Volume II

In response to Comment I006-309, an analysis was conducted of interim terminal stations for the F-B LGA. The analysis follows below. Although the Technical Appendix is new text, for readability, Technical Appendix 2-I has not been underlined.

Appendix 2-I: Interim Terminal Station

Figure 2-I-1 Interim Terminal Station Concept A

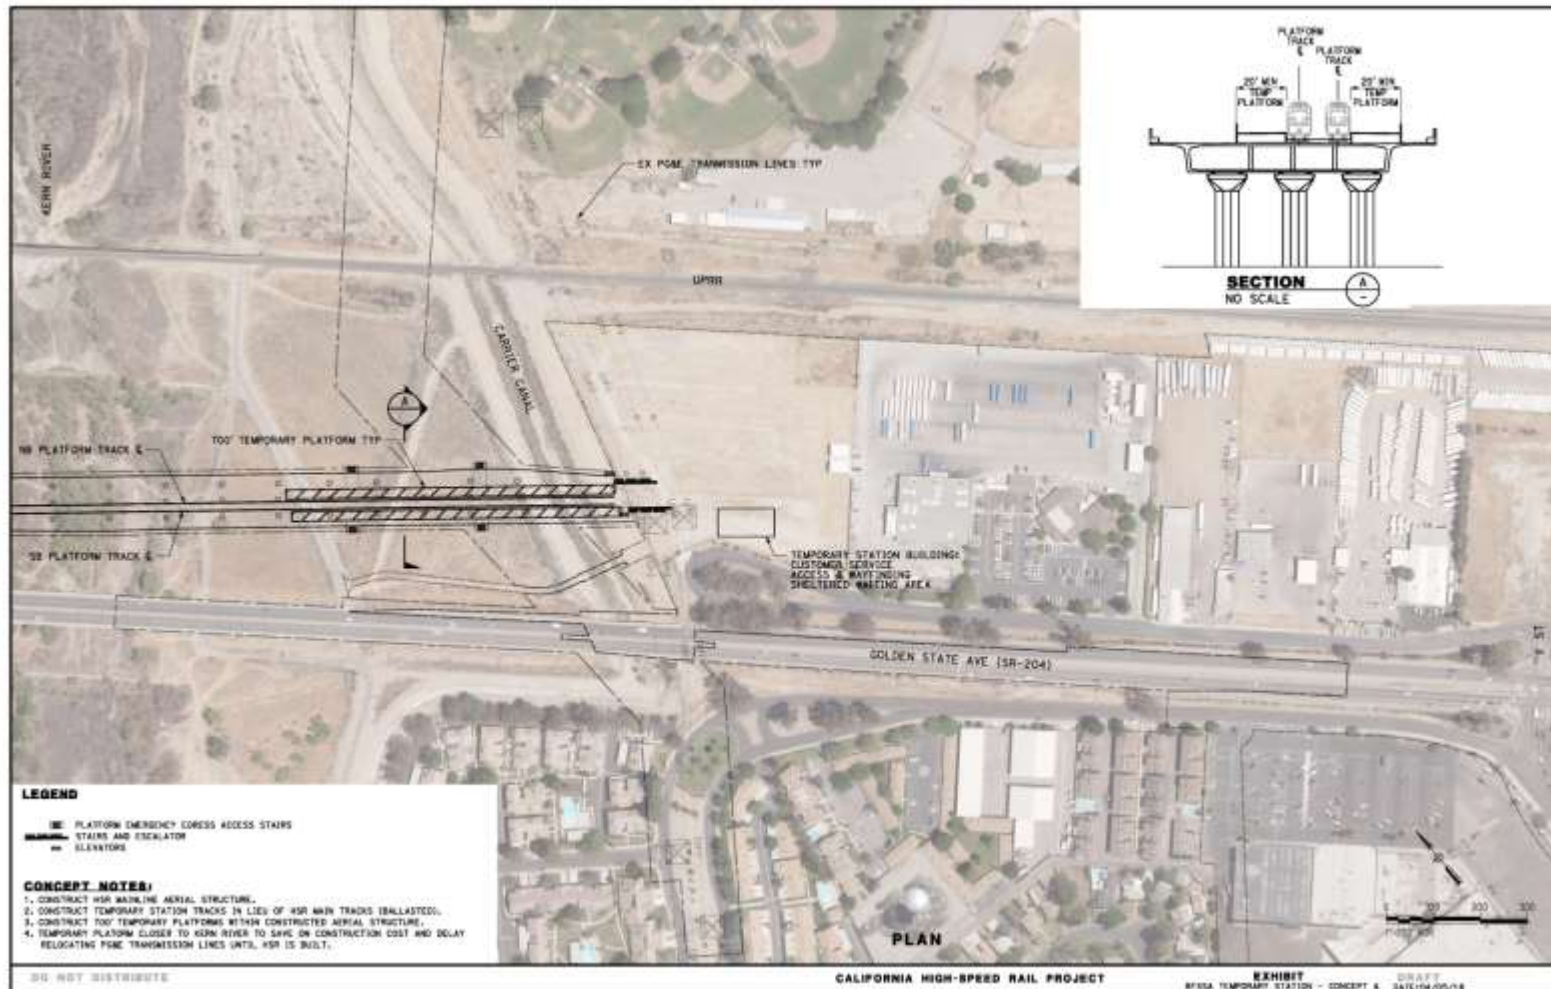
Concept A (Figure 2-I-1) would be an approximately 4.1-acre site³ and would require the construction of temporary platforms (700 feet in length) along the proposed mainline tracks north

of the Carrier Canal. Existing overhead, high voltage power lines would remain in place. Platform access would be provided from the southern end of the platforms, and emergency egress points would be provided between the Carrier Canal and the Kern River. This concept would minimize construction costs by placing the platforms over the Carrier Canal and would include the development of a temporary station building for customer service. Concept A would require removal of temporary features once the full buildout station is constructed. The cost associated with the removal of the temporary features would be calculated based on design plans, if this concept is selected.

Figure 2-I-2 Interim Terminal Station Concept B

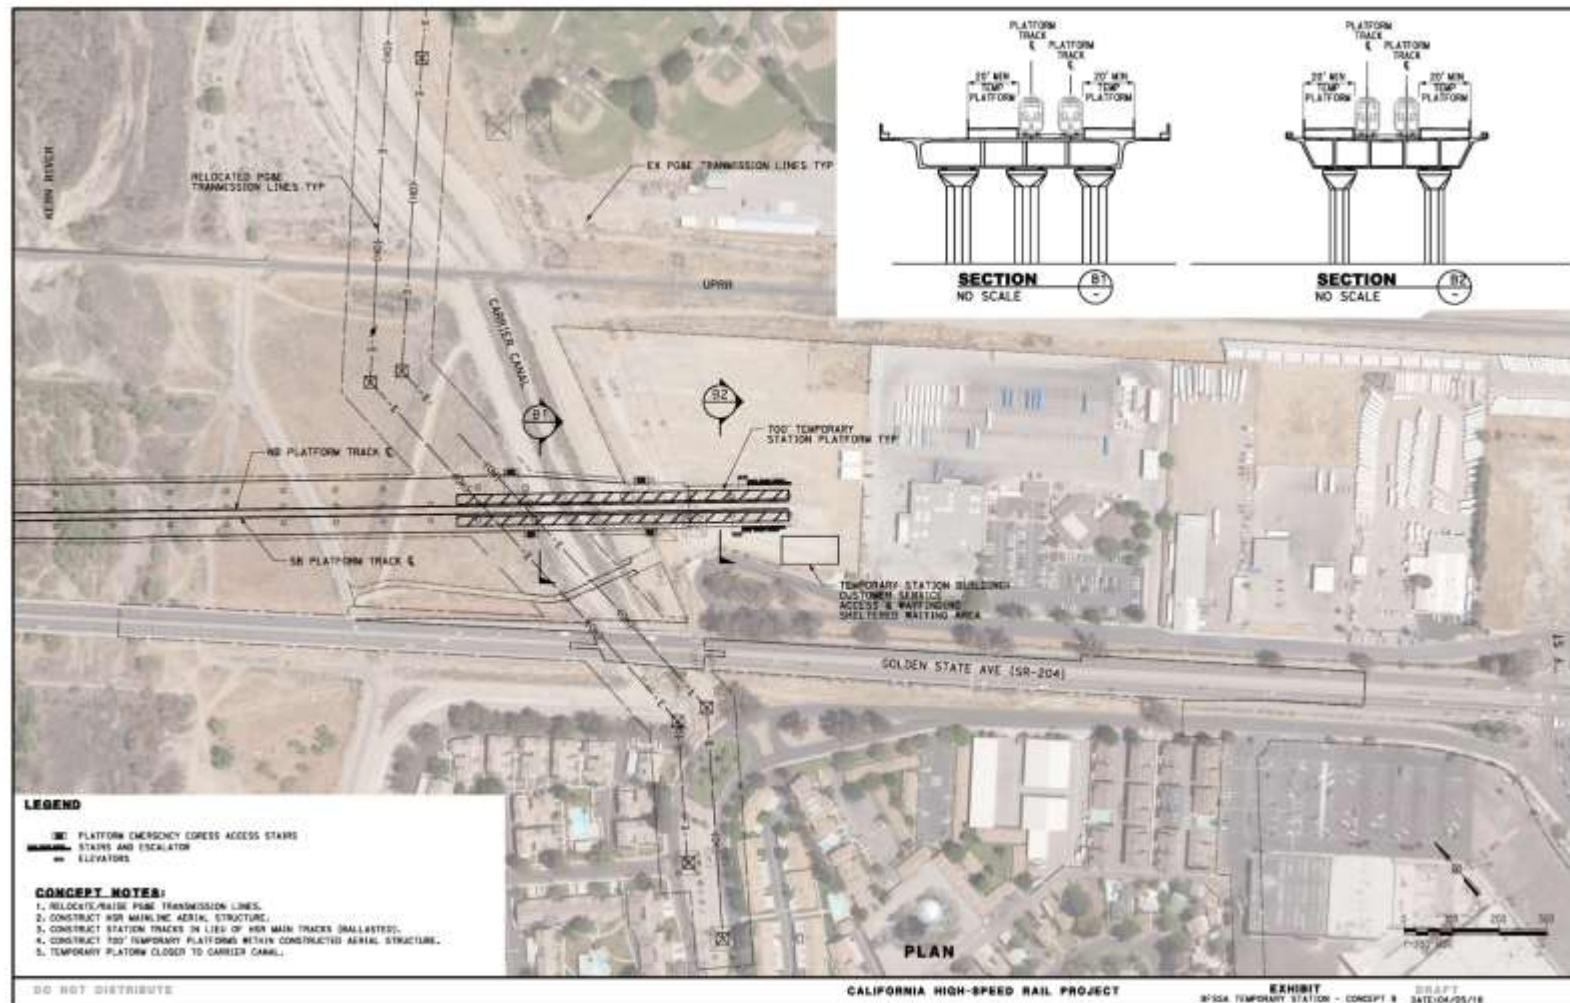
Concept B (Figure 2-I-2) would be an approximately 16.5-acre site and would require the construction of the temporary platforms (700 feet in length) within the proposed station footprint to accommodate egress points on the south side of the Carrier Canal. Temporary platforms would straddle the Carrier Canal and would be constructed along the proposed mainline tracks. Platform access would be provided from the southern end of the platforms. Overhead, high voltage power lines would require relocation and would be located over the northern end of the temporary platform. This concept would include the development of a temporary station building for customer service. Concept B would require removal of temporary features once the full buildout station is constructed. The cost associated with the removal of the temporary features would be calculated based on design plans, if this concept is selected.

Figure 2-I-3 Interim Terminal Station Concept C

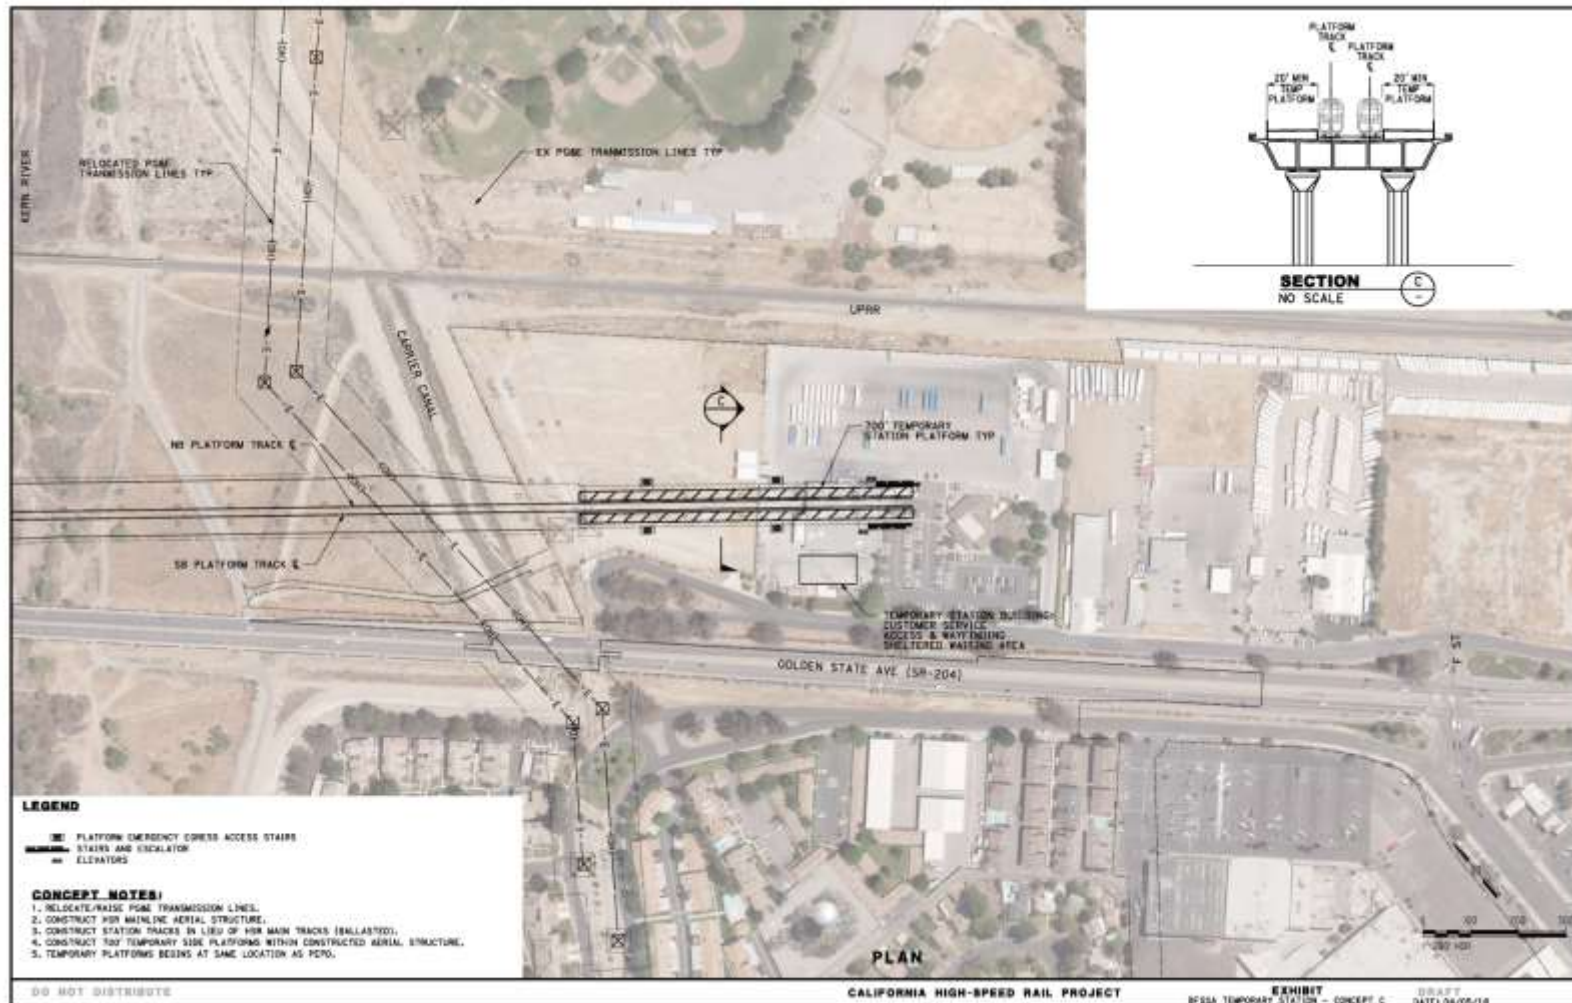
Concept C (Figure 2-I-3) would be an approximately 16.5-acre site and would require the construction of the temporary platforms (700 feet in length) entirely on the south side of the Carrier Canal and along the proposed mainline tracks. Access under Concept C would occur anywhere along the platform for both normal use and emergency egress. Overhead, high voltage power lines would require relocation. This concept would include the development of a temporary station building for customer service. Concept C would require removal of temporary features once the full buildout station is constructed. The cost associated with the removal of the temporary features would be calculated based on design plans, if this concept is selected.

Figure 2-I-4 Interim Terminal Station Concept D

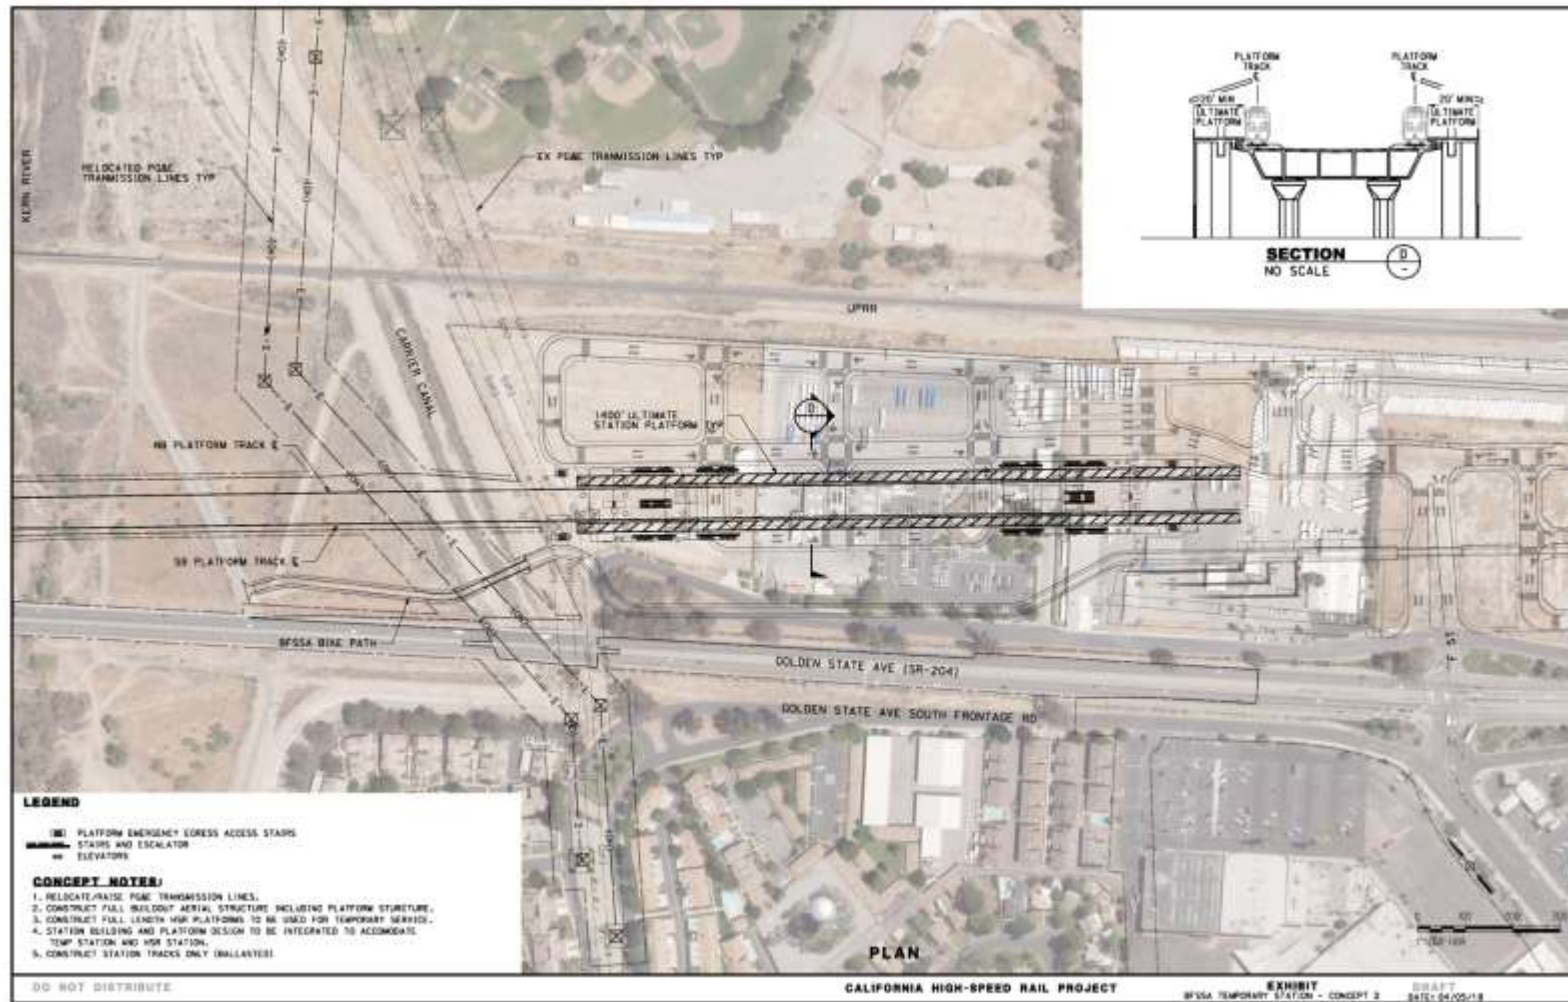
Concept D (Figure 2-I-4) would be an approximately 16.5-acre site and would be the most expensive of the four concepts, because it would require construction of the proposed full buildout features in their proposed locations including the station tracks and platforms (1,400 feet in length). Mainline and station track alignments would be constructed in their permanent position with only minor shifts in turnout locations. Concept D would require the relocation of the overhead, high voltage power lines. Mainline and station track alignments under Concept D would be constructed in their permanent positions; therefore, under Concept D, there would be no throw away costs due to the removal of temporary features.
